POLICY ISSUE
(Notation Vote)

SECY-91-220

Subject: YANKEE ROWE PRESSURE VESSEL EMBRITTLEMENT ISSUES

PROPOSED DECISION UNDER 10 CFR SECTION 2.206

Fig. 8 P(F|E) per reactor year as a function of flaw orientation at $RT_{NDT} = 286^{\circ}F$.

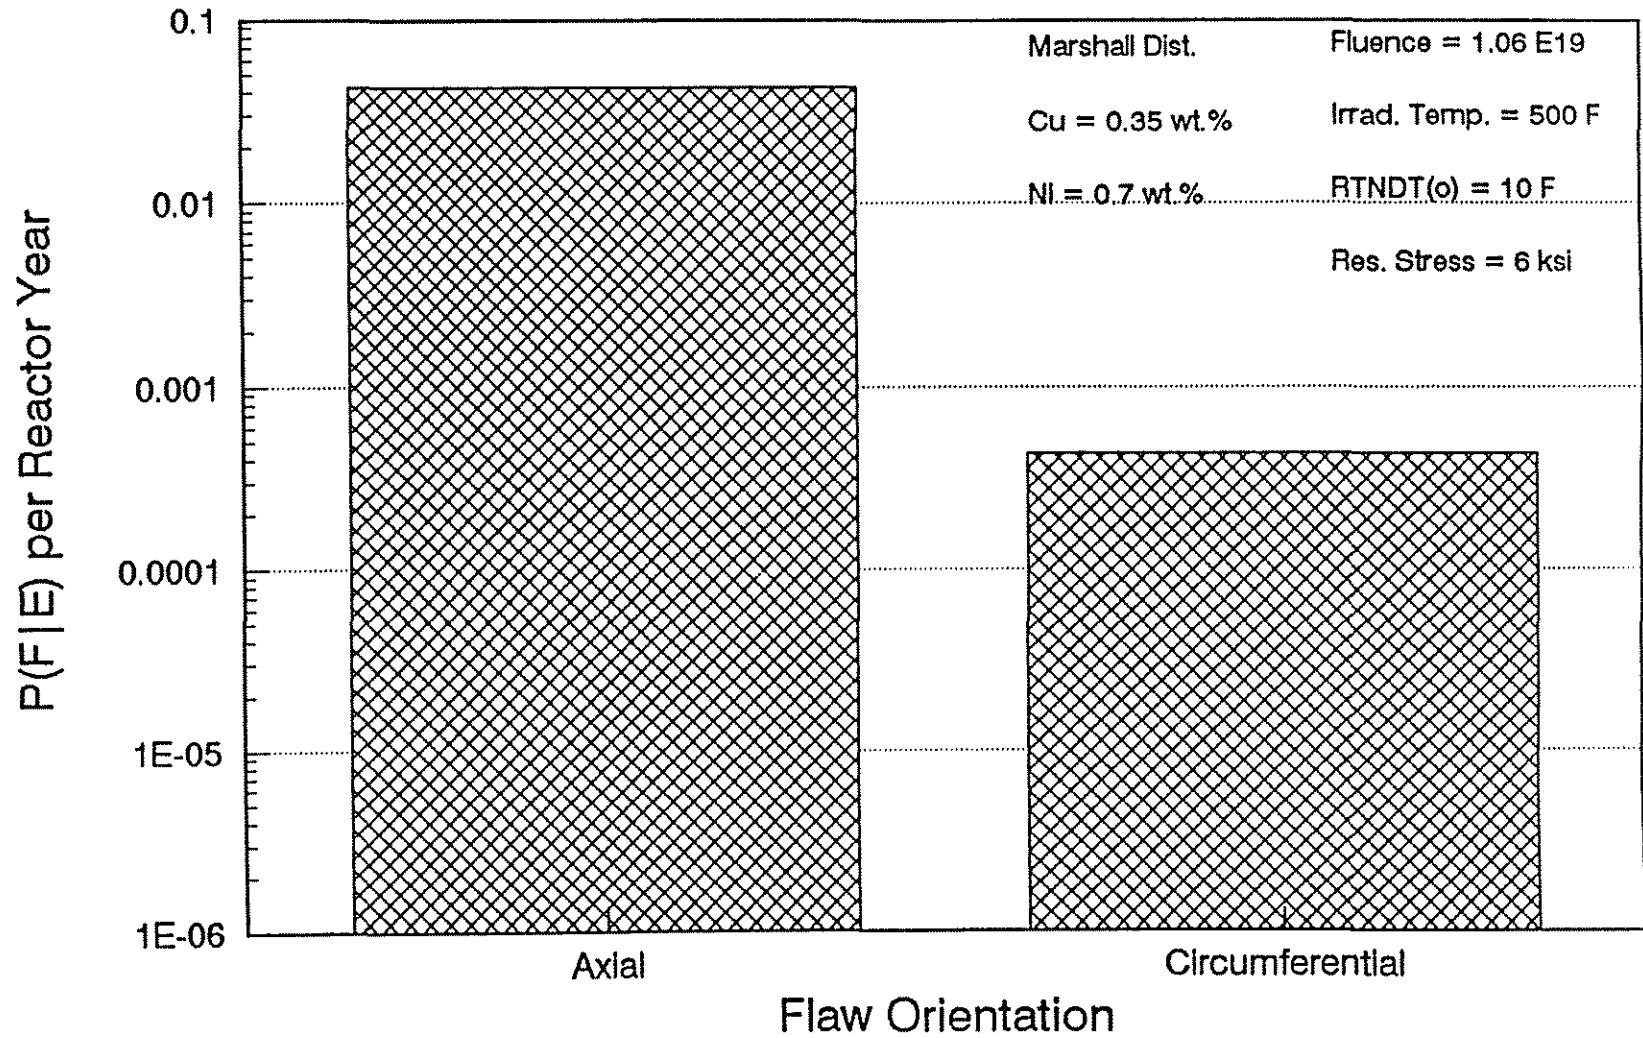
Figure 8 illustrates the effect on $P(F|E)$ of changes in flaw orientation. These calculations were performed for 0.35 wt.% Cu and 0.7 wt.% Ni, with the same volume of material and the Marshall flaw distribution. Changing the flaw orientation from axial to circumferential reduces $P(F|E)$ by a factor of 100.

Fig. 9 P(F|E) per reactor year for long flaws and finite length (length is 6 times depth) flaws, at fluence levels of 1.25 and 2.5 x 10¹⁹ n/cm², E > 1 MeV.

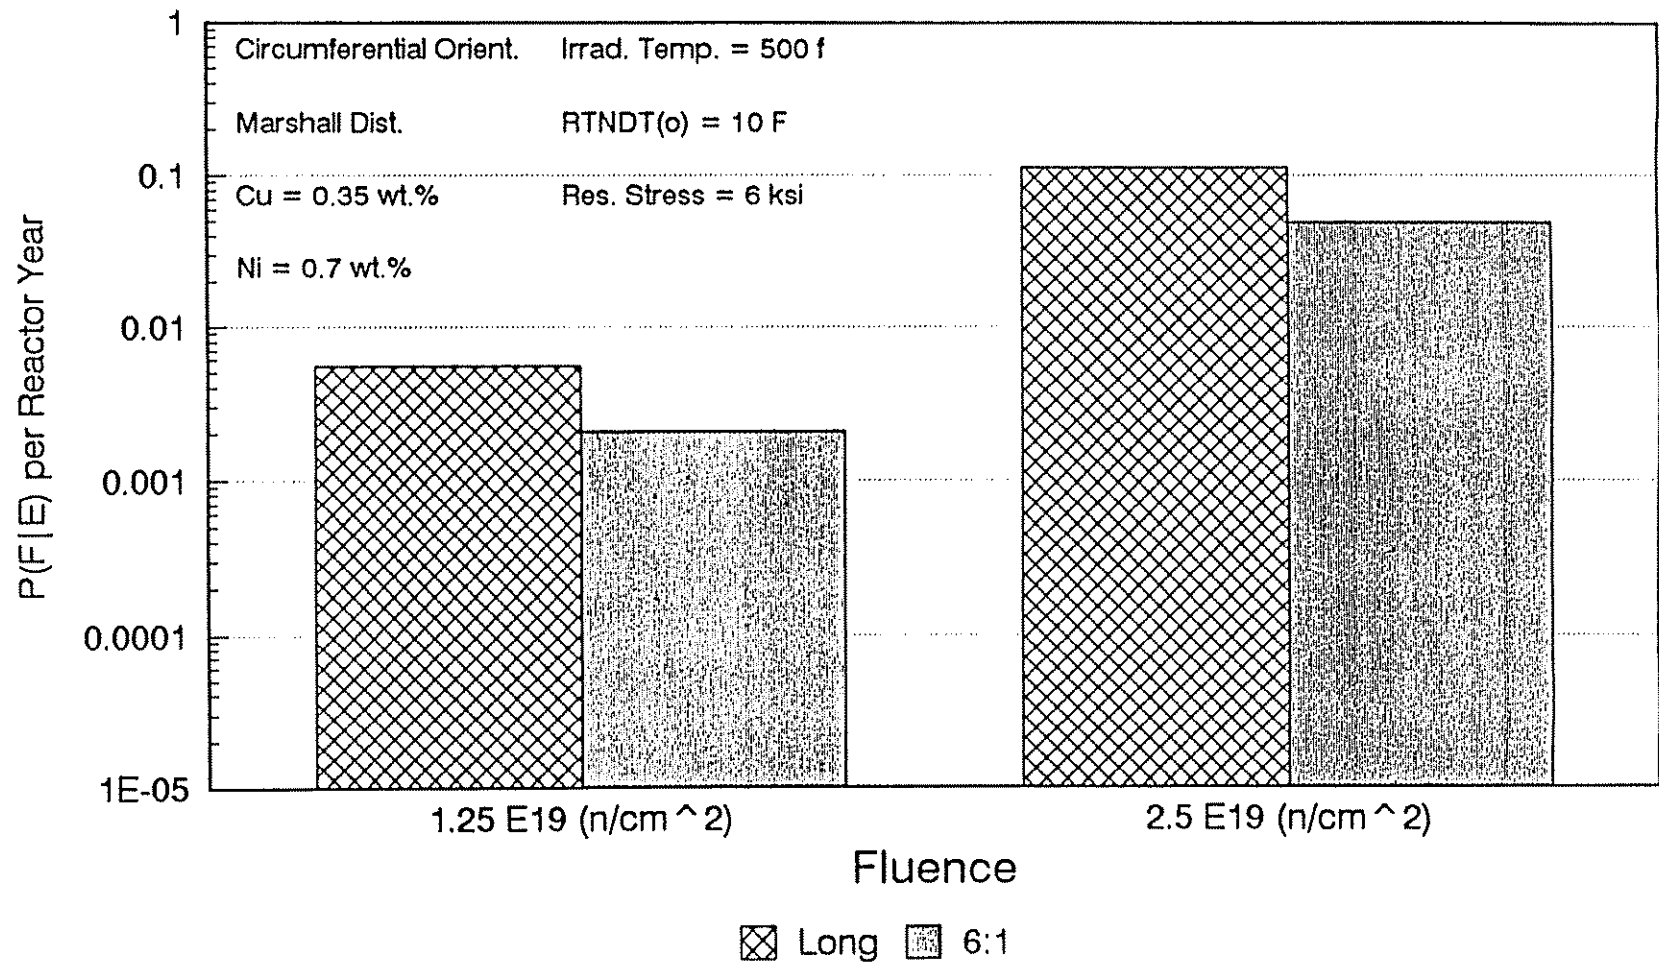
Finally, Figure 9 examines the effect on $P(F|E)$ of the long-flaw assumption for the conditions of a circumferentially oriented flaw with 0.35 wt.% Cu and 0.7 wt.% Ni. The two conditions examined are for an infinitely long flaw and

Fig. 10 Embrittlement trends for the upper plate and the lower plate, using Regulatory Guide 1.99 Rev. 2 and the NRC staff estimates.

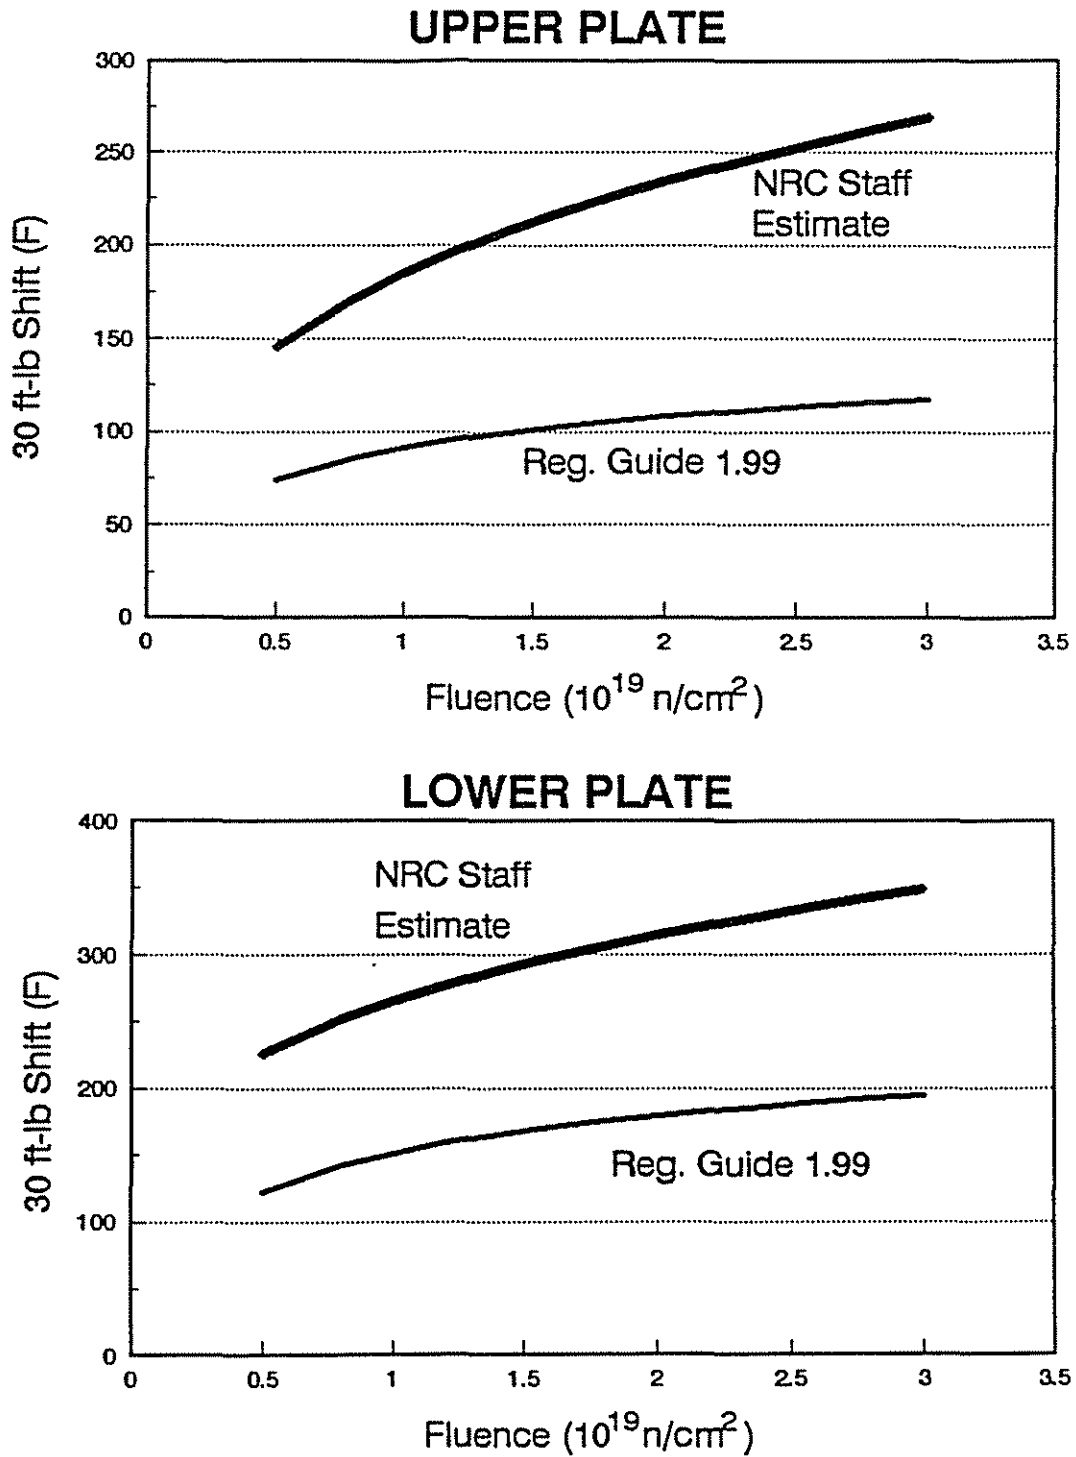
Unlike the weld materials, the embrittlement trends of the plates are not adequately defined by Regulatory Guide 1.99, Rev. 2. For the upper plate, the specific trend of embrittlement as a function of fluence (Figure 10(a)) incorporates the Yankee Rowe surveillance data and surveillance data from the Belgian BR-3 reactor, with a correction to match the irradiation temperature of the BR-3 surveillance data with the Yankee Rowe operating temperature. For the lower plate, a nickel adjustment is made to the upper plate trend, as shown in Figure 10(b).

Fig. 11 $P(F|E)$ per reactor year as a function of irradiated reference temperature.

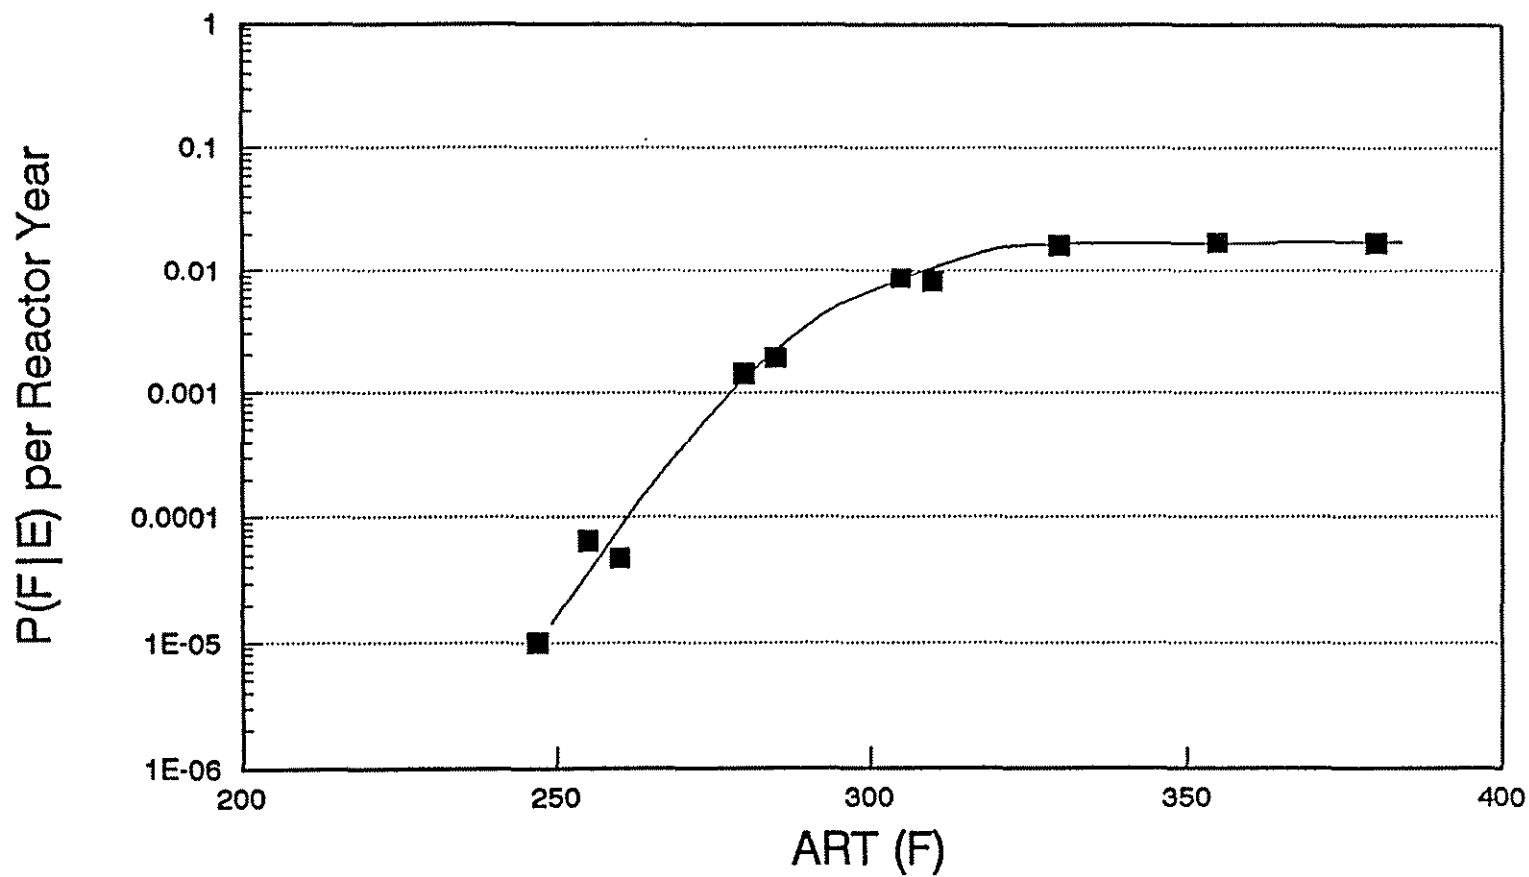
The impact of adjusted reference temperature (ART) on $P(F|E)$ is illustrated in Figure 11. At adjusted reference temperature values of 330°F and higher, the $P(F|E)$ reaches a nearly constant level, indicating that the failure probability will not increase at higher ART levels. At an ART of 230°F, the $P(F|E)$ is less than $1E-6$ (i.e., no failures in 1,000,000 simulations).

Fig. 12 P(F|E) per reactor year as a function of initial RT_{NDT}, for shifts of 275°F and 325°F.

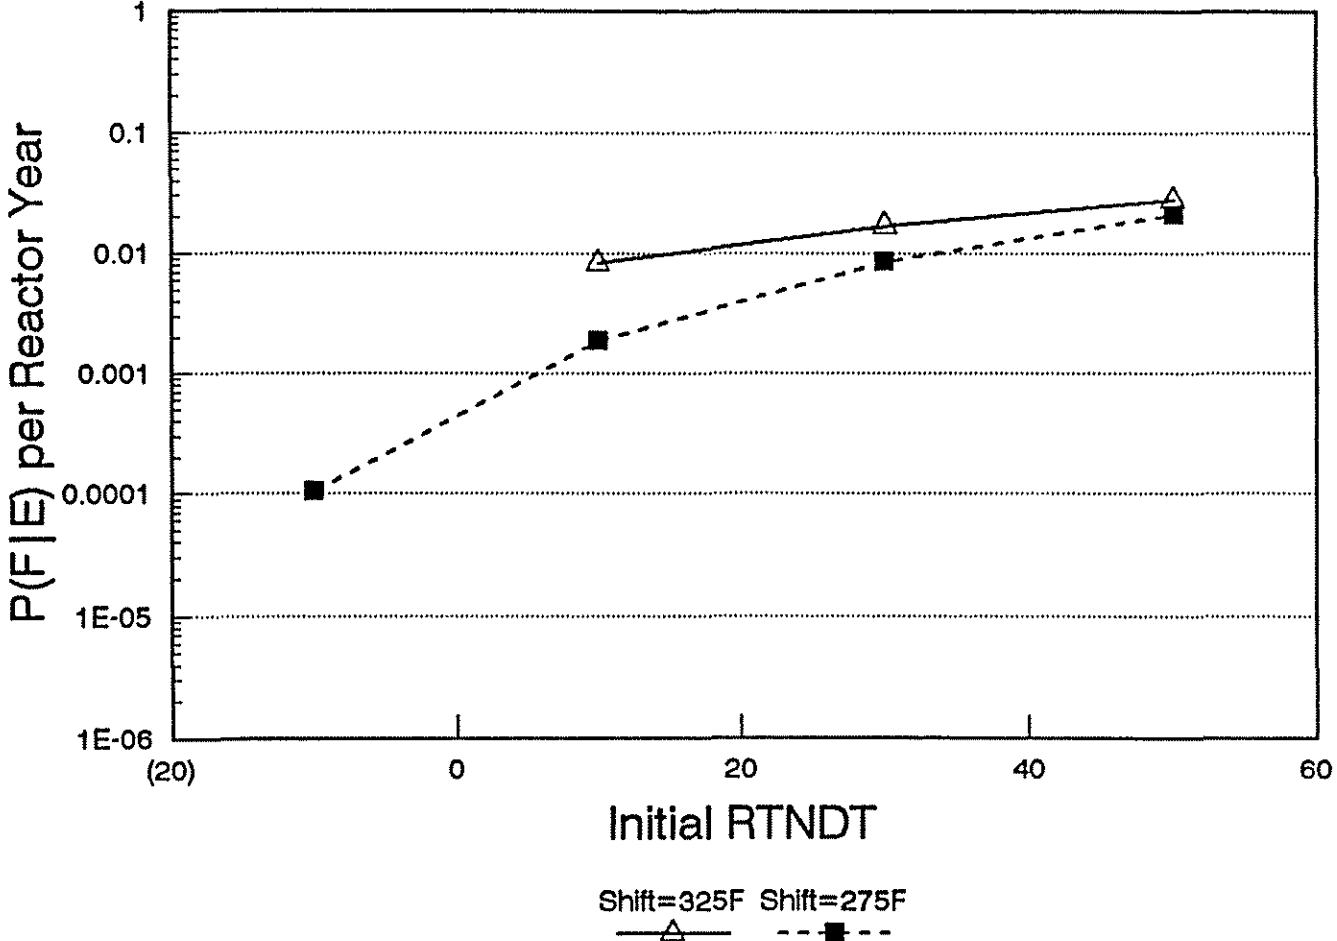
The impact of initial RT_{NDT} on $P(F|E)$ is illustrated for a high shift in ART (285°F) and a low shift in ART (355°F) in Figure 12. Hence, the ART was allowed to change. As illustrated in Figure 12, the two ART levels exhibit different behaviors. The higher of the two exhibits no substantial effect of varying the initial RT_{NDT} , whereas the lower of the two exhibits a distinct difference, of about two-orders of magnitude change in $P(F|E)$ between the lowest and the highest initial RT_{NDT} values. This difference in behavior can be rationalized in Figure 11. Specifically, the higher of the ART shifts is on the plateau portion of the curve in Figure 11, where the $P(F|E)$ is relatively insensitive to the ART level. In contrast, the higher of the two ART shifts is on the sloped portion of the curve, which is highly sensitive to the ART.

Fig. 14 $P(F|E)$ per reactor year as a function of variability in the initial RT_{NOT} and the reference temperature shift, for ART values of $285^{\circ}F$ and $355^{\circ}F$.

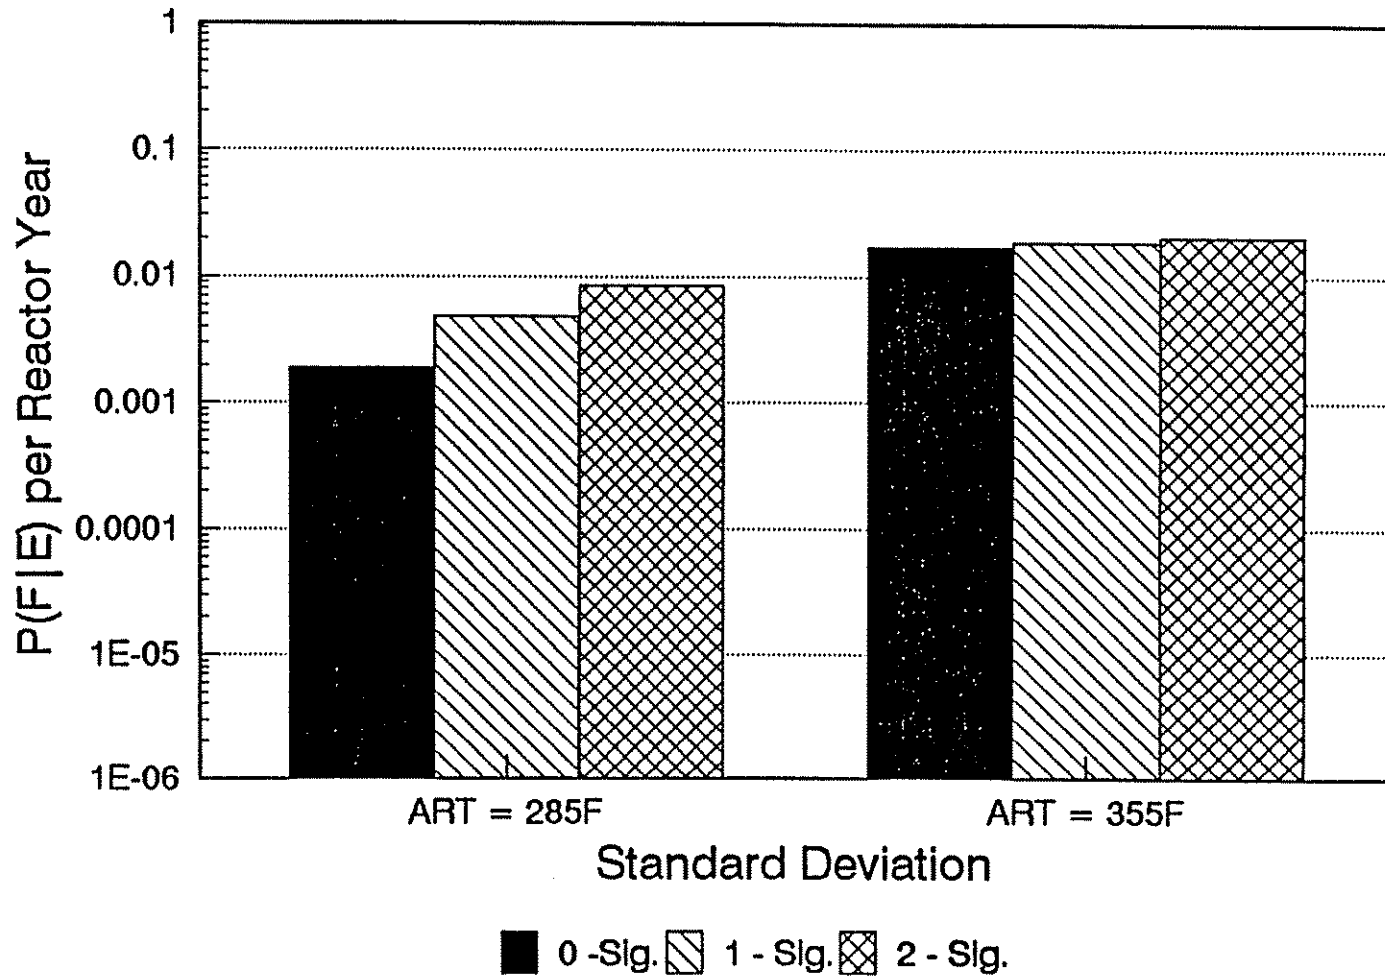
The effect of modeling uncertainty in the initial RT_{NDT} and the embrittlement shift were also evaluated (Figure 14). In one case (indicated as "1-sig" in the figure), one standard deviation levels were set as 17°F on shift and 10°F for initial RT_{NDT} (the value for plates in Reg. Guide 1.99 Rev. 2 for shift and a typical value for initial RT_{NDT}); these values were doubled for a second case (indicated as "2-sig" in the figure). As illustrated in Fig. 14, the higher ART level is relatively insensitive, whereas the lower ART level is moderately sensitive (about a factor of two as the uncertainty level is increased).

Fig. 15 $P(F|E)$ per reactor year as a function of flaw distribution, for ART values of 285°F and 355°F.

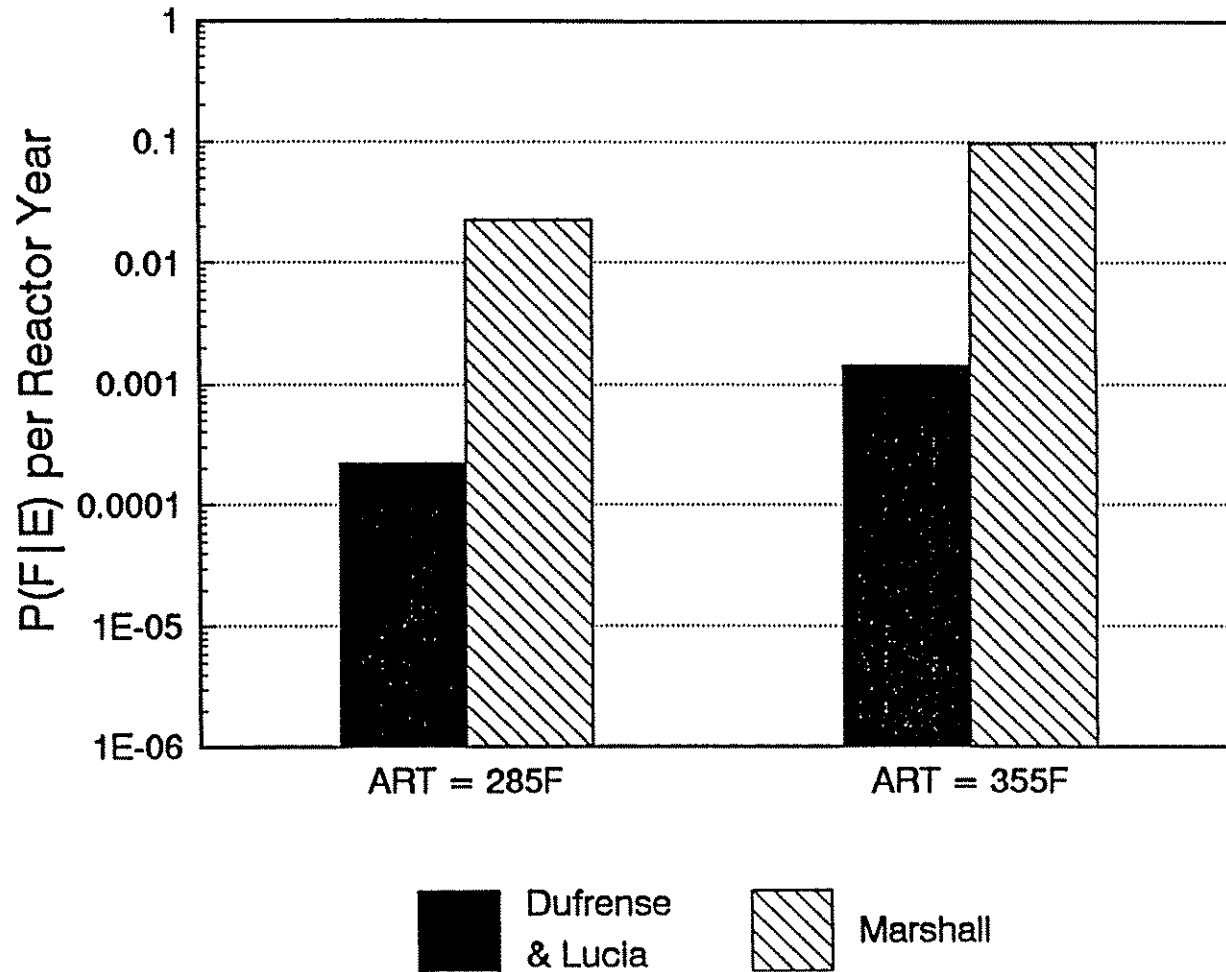
The effect of flaw distribution was evaluated with the VISA-II code, in a manner similar to that used for the welds. As illustrated in Figure 15, the Dufrense and Lucia distribution results in $P(F|E)$ values which are about two orders of magnitude (about a factor of 100) less than those for the Marshall distribution. This is consistent with the results for welds, as expected.
